TECHNICAL BULLETIN INDEX
Sorted by Bulletin Number
06/25/86

DATE: November 5, 1981

BULLETIN NO.: HD:1

PRODUCT: 26-4150

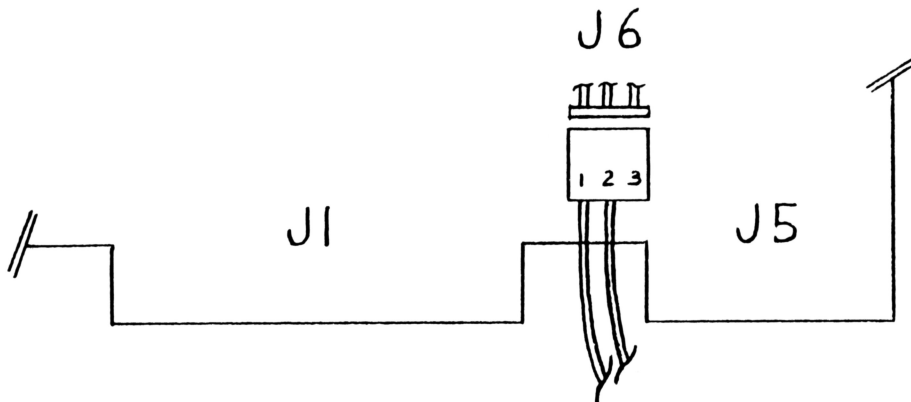
DISCUSSION: Noise on the 5 volt power supply can cause either the stepper control board or ROM to intermittently lose which track the head is on. When this happens the read is aborted because the head is on the wrong track and a retry occurs. Usually the read is successful after one retry, however this does slow down operation of the system because the restore is done at a much slower rate.

PROCEDURE: This applies to all drive logic boards that do not already have this modification. A 100 uf capacitor rated at 10vdc or more should be installed across the +5 volt power supply near location 3C.

The + lead of the cap to the trace coming from pin 18 of location 3C. Then connect the - lead of the cap to the nearby trace connecting C56, C74, & R46 (these are in the group of components in front of location 3C and the trace is between them and J3).

BULLETIN NO.: HD:10

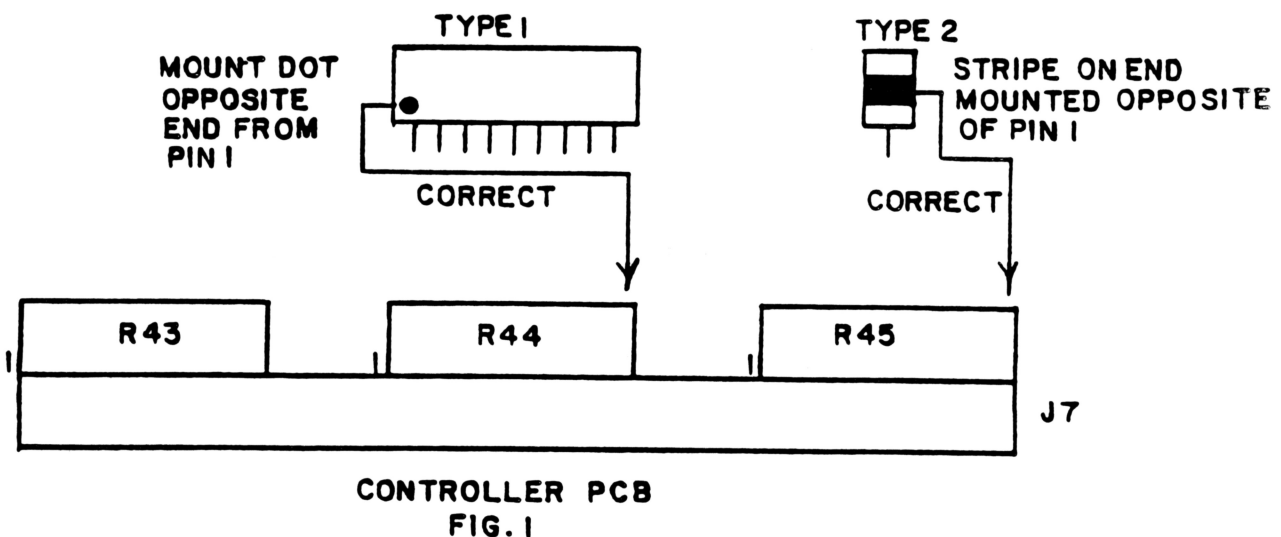
DISCUSSION: During manufacture, resistor packs R43, R44, and R45 may have been installed backwards. With the resistor packs installed backwards the open collector inputs and outputs are not tied to a pullup voltage.

PROCEDURE: Remove the cover of the primary hard drive and remove the controller board. Locate resistor packs R43, R44, and R45 adjacent to connector J7. If the packs are backwards (refer to fig. 1), remove them and replace them with part# ARX-0331 noting correct orientation (see fig. 1).

BULLETIN NO.: HD:12

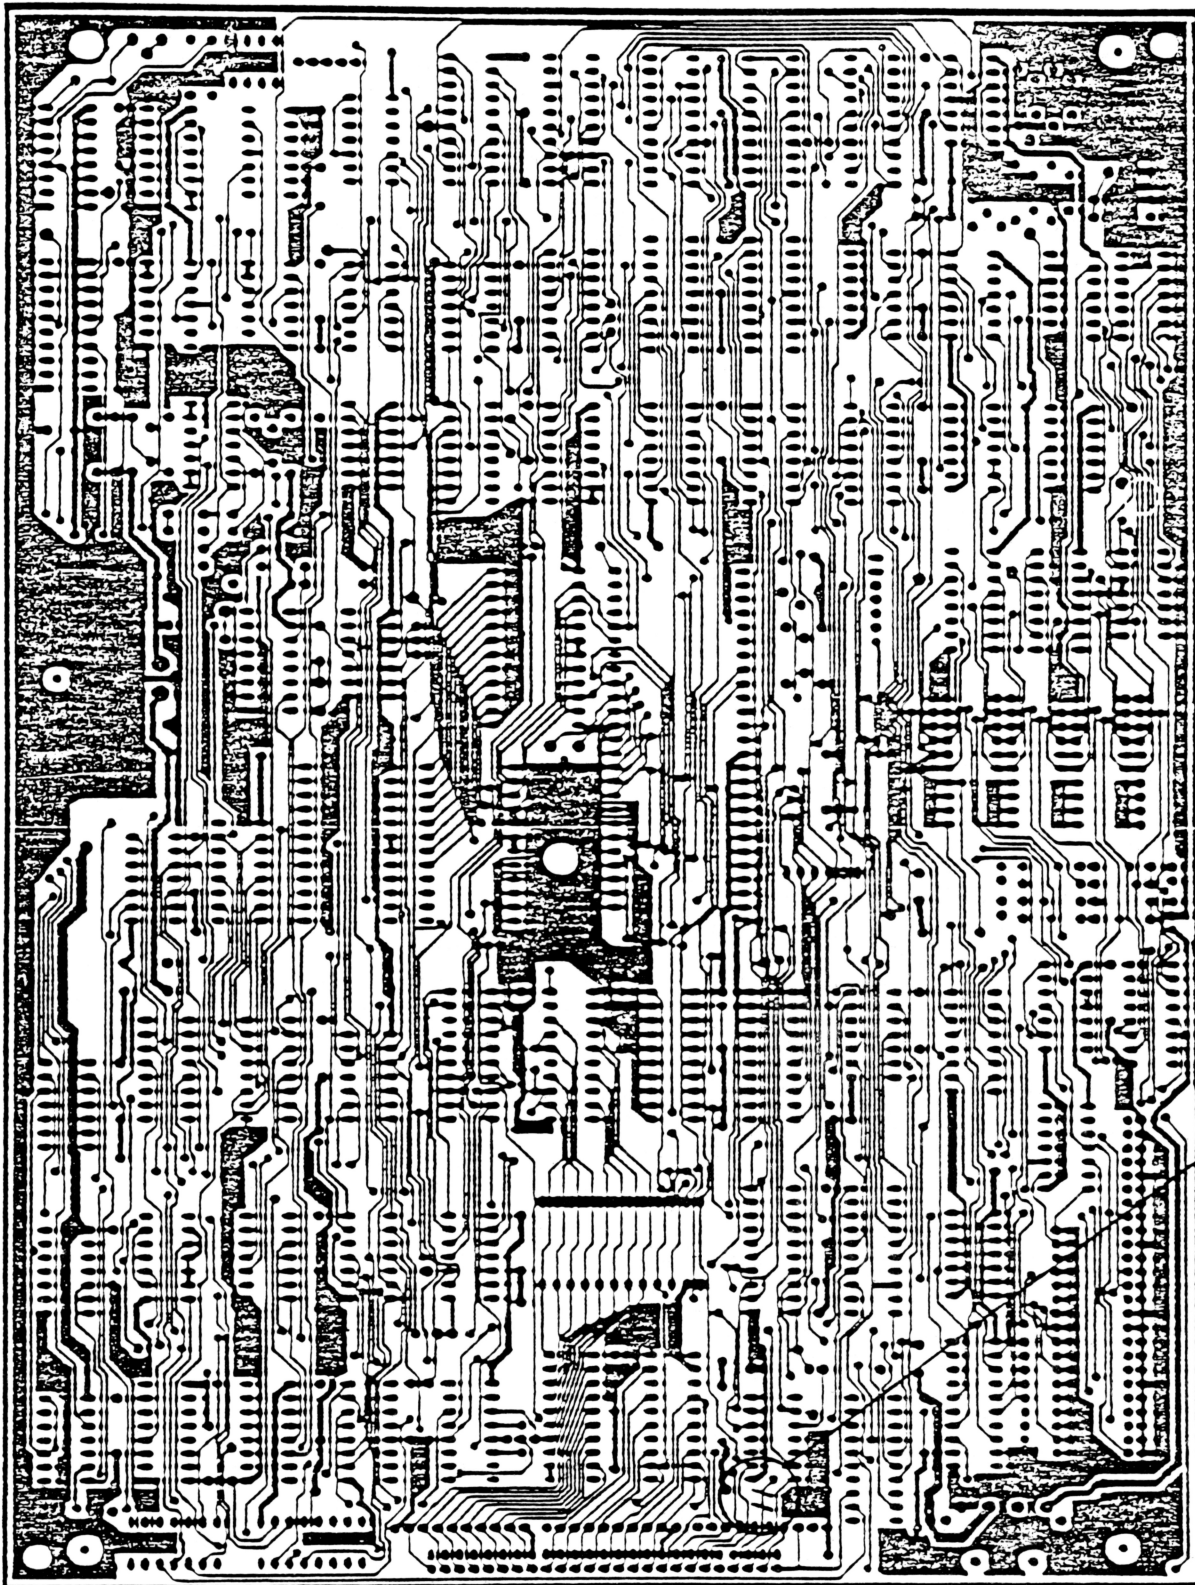
PART A) Modify the Hard Drive Controller PCB inside the Hard Drive. You will need An X-acto™ knife, some wire wrap wire, wire cutters, and soldering equipment.

Make the following cut on the FOIL side of the PCB.

Cut the trace going from J7 pin 41 to U73 pin 5.

Make the following cut on the COMPONENT side of the PCB.

Cut the trace going from J7 pin 43 to U73 pin 7.

Make the following jumpers on the COMPONENT side of the PCB.

- 1) Jumper U38 pin 11 to U72 pin 1
- 2) Jumper U72 pin 2 to J7 pin 41
- 3) Jumper U58 pin 10 to U72 pin 3
- 4) Jumper U72 pin 4 to J7 pin 43

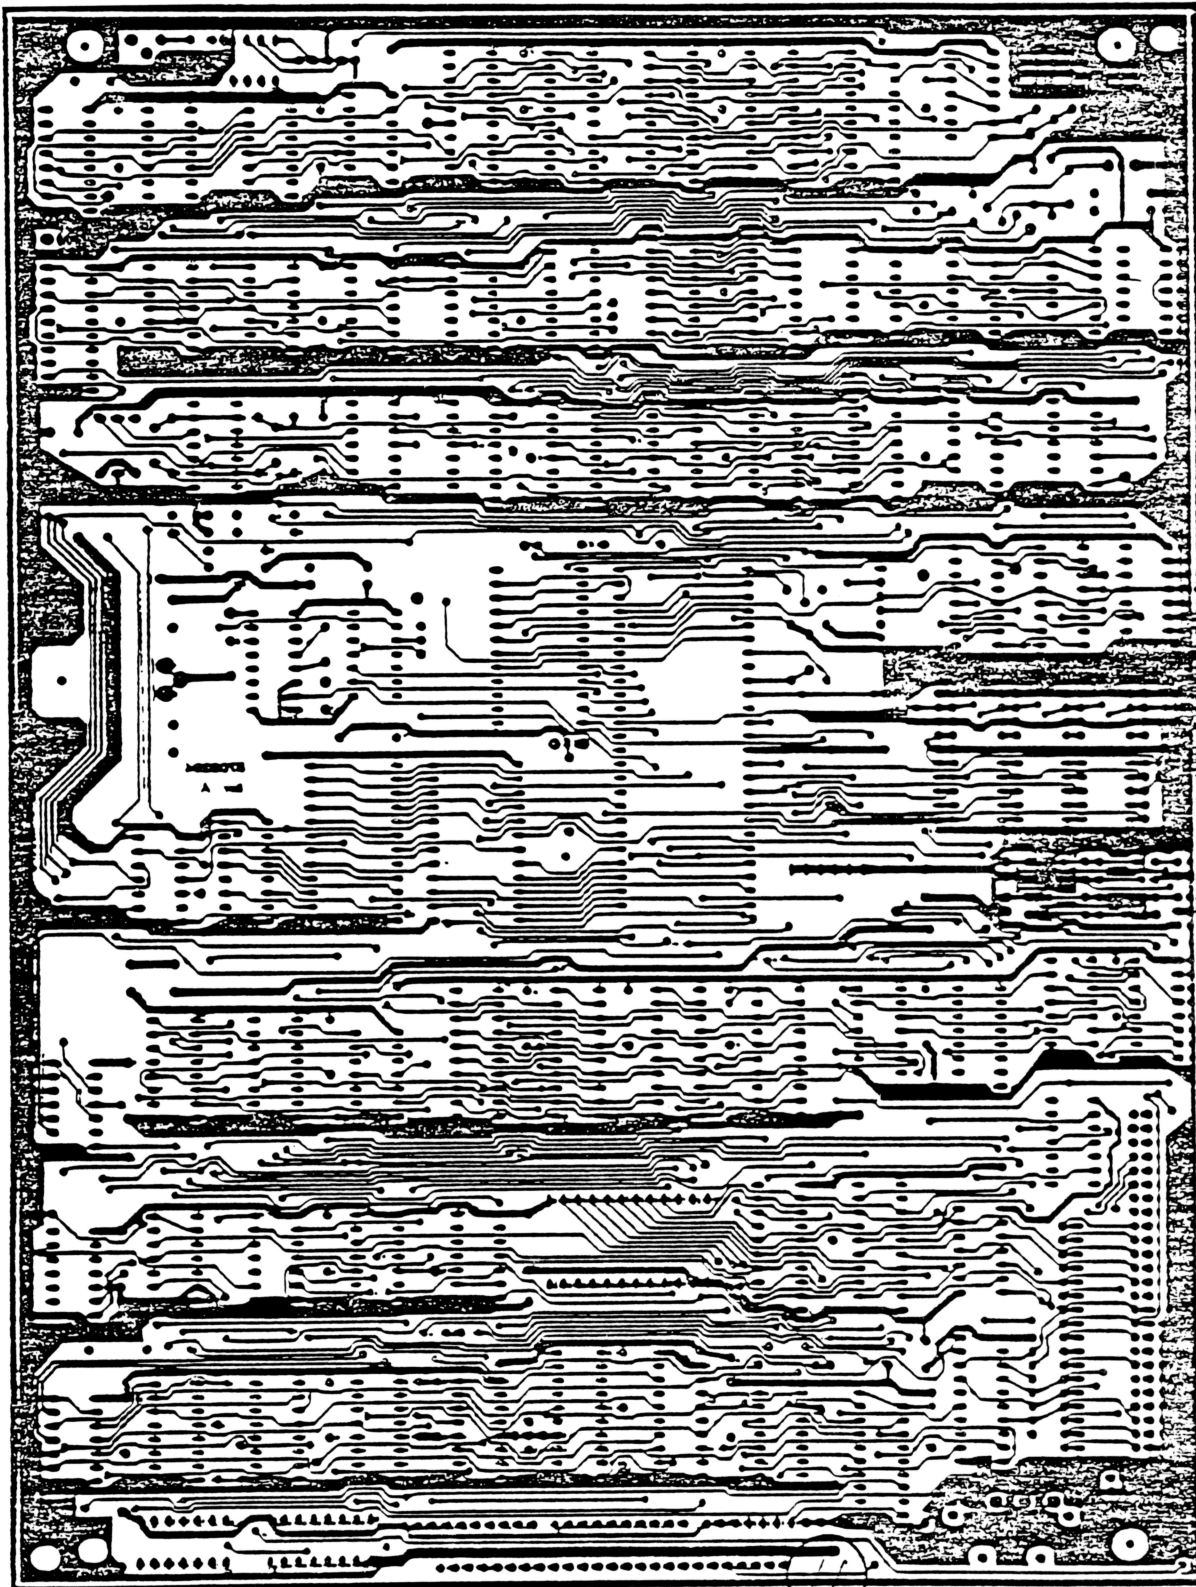
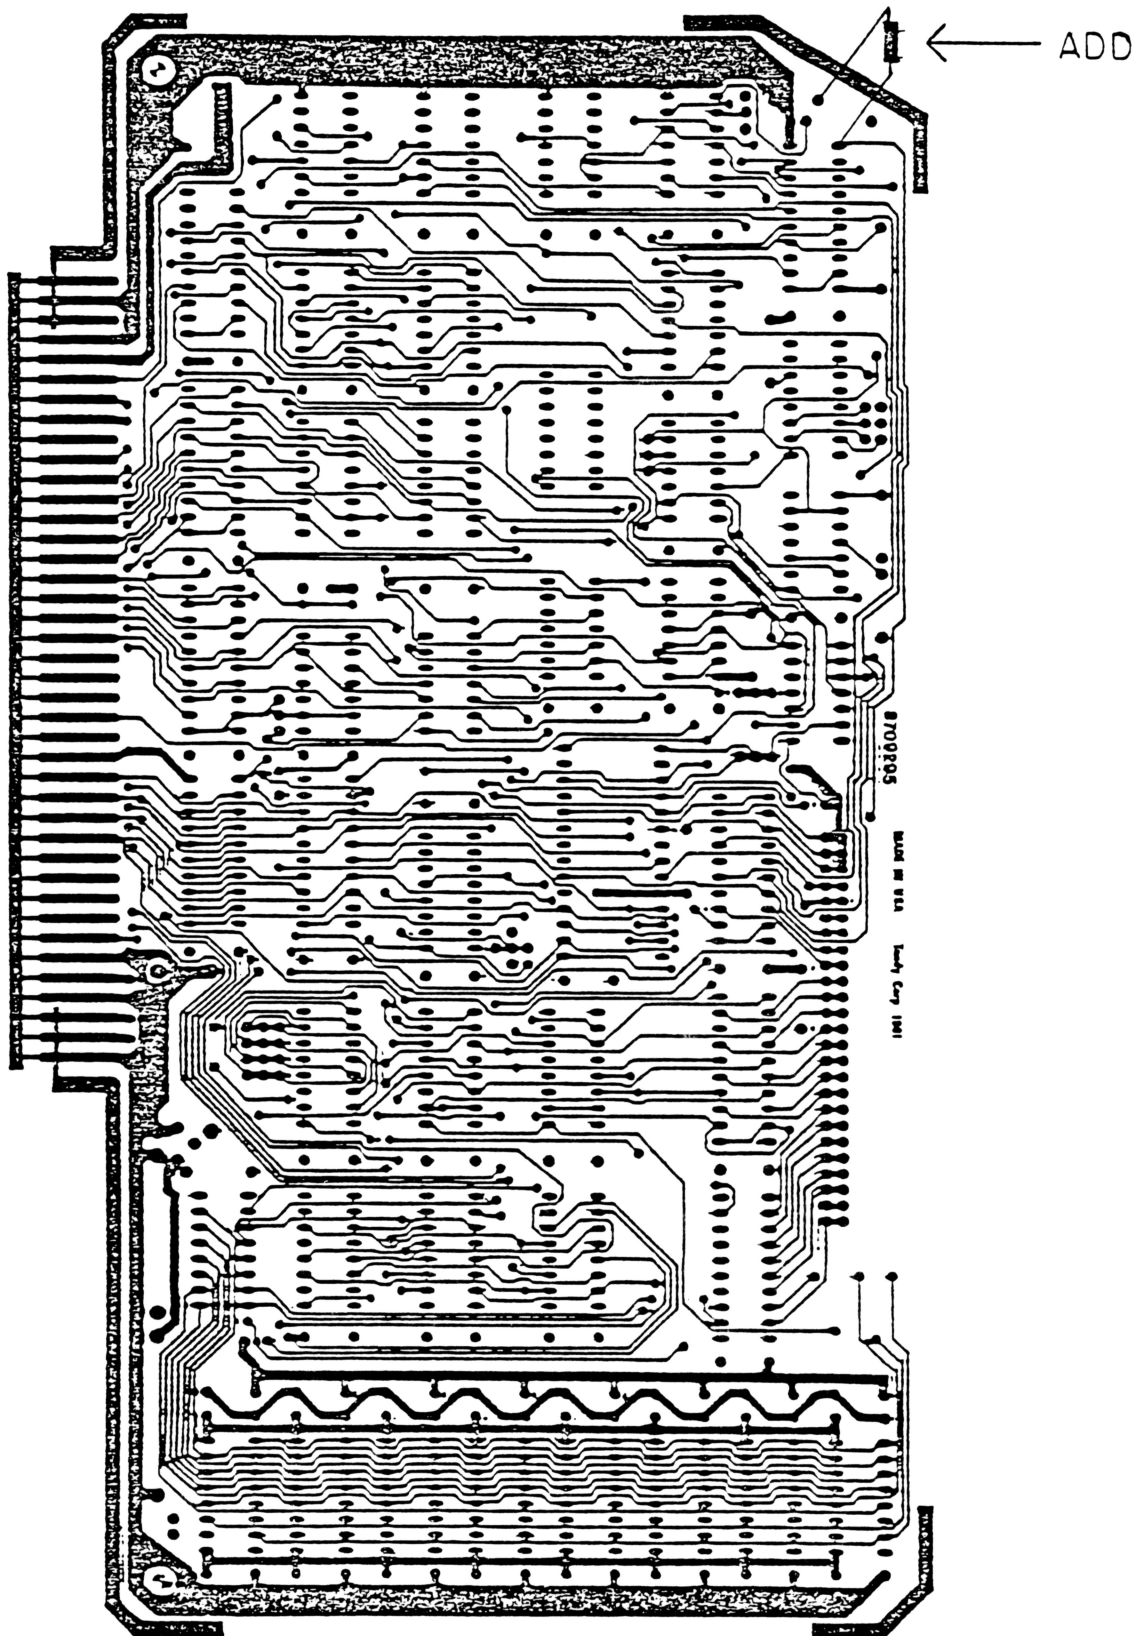
PART B) Modify the Hard Drive Interface Card if available. You will need two 470 ohm 1/4 watt 5% resistor (N-0169EEE 26-9999R), wire cutters, and soldering tools.

Install the resistor on the FOIL side of the Interface card.

- 1) Cut the resistor leads to 3/8-inch in length.
- 2) Solder one end of the resistor to U12 pin 11. Solder the free end of the resistor to +5 volts (see diagram).
- 3) Remove R11 and replace it with a 470 ohm resistor.

Figure 1

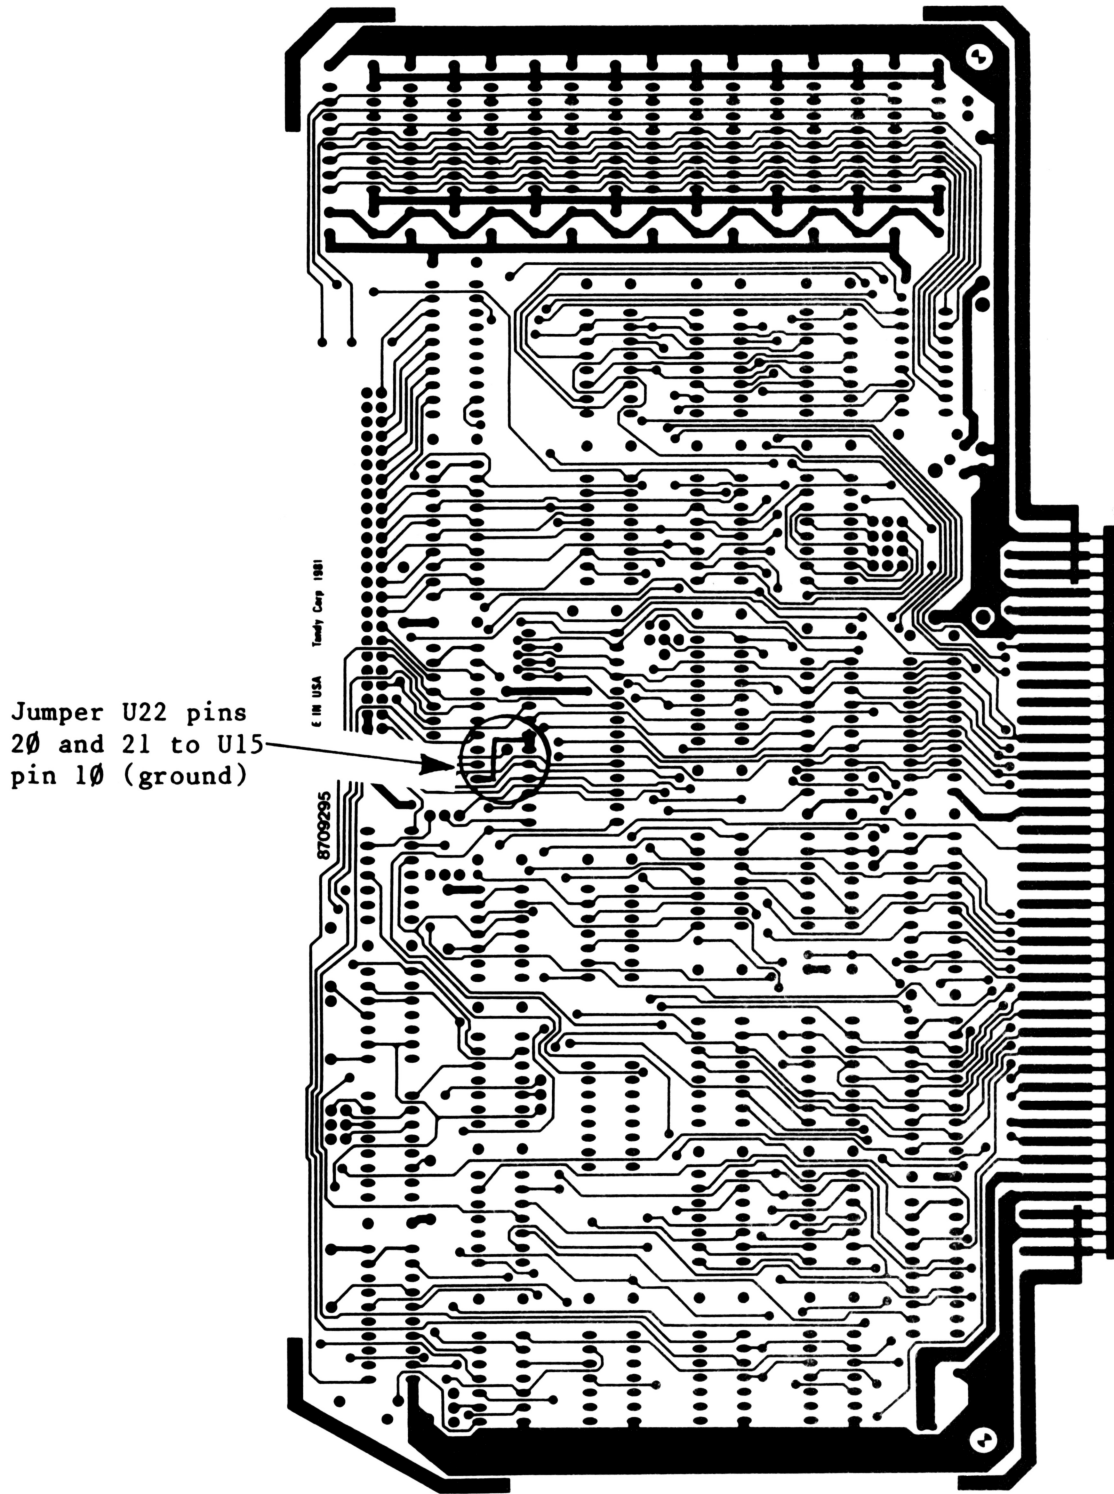
DISCUSSION: Unused CLK/TRG inputs on the CTC chip, when left floating, may cause false triggering of the CTC chip, resulting in system lockup. To prevent this from occurring these inputs need to be grounded. All units in for service **MUST** be checked for this modification.

PROCEDURE: On the foil side of the PCB jumper U22 pins 20 and 21 to U15 pin 10 (Refer to Figure 1).

CIRCUIT DIAGRAM

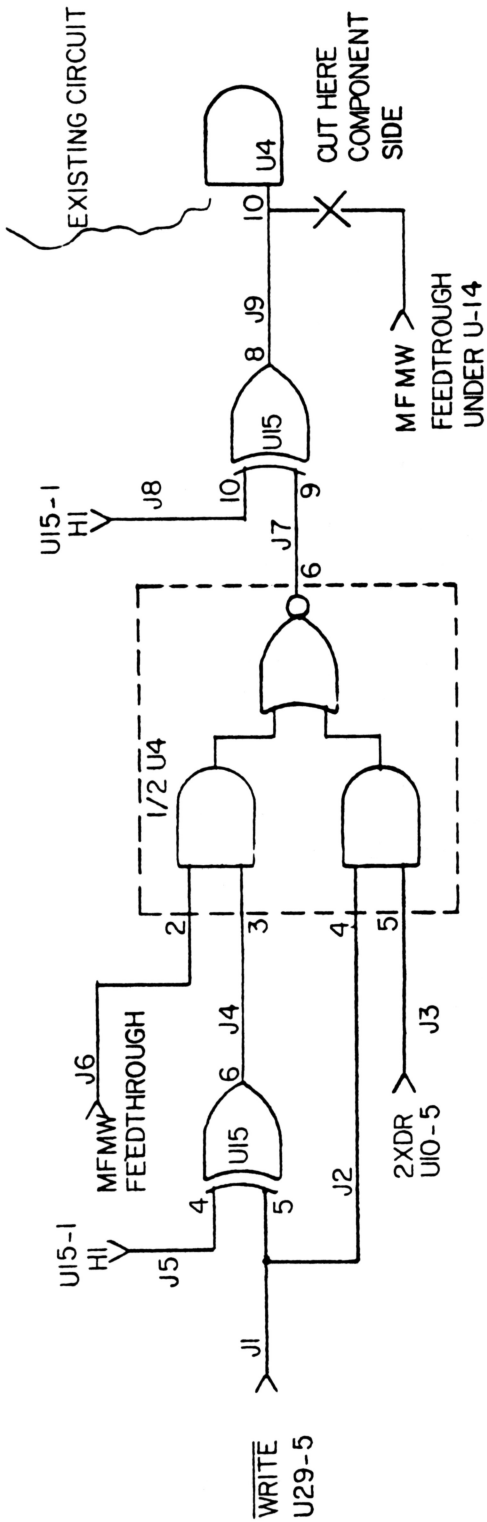
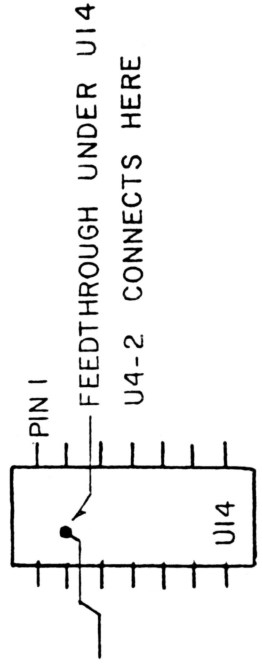
DISCUSSION: During power-up and idle conditions, the VCO attempts to lock onto a 10 MHZ signal. In early hard drive controllers, only a 5 MHZ signal is available during this period causing the VCO to try to lock on to a harmonic. This results in unreliable operation. This modification will provide the VCO with a 10 MHZ clock during idle periods.

PROCEDURE: This procedure is comprised of one trace cut, and nine jumpers. All jumpering is to be done on the solder side of the controller PCB. Please refer to the second page of this bulletin for the proper position of the trace cut, as this is very important. Below is a summary of the modification.
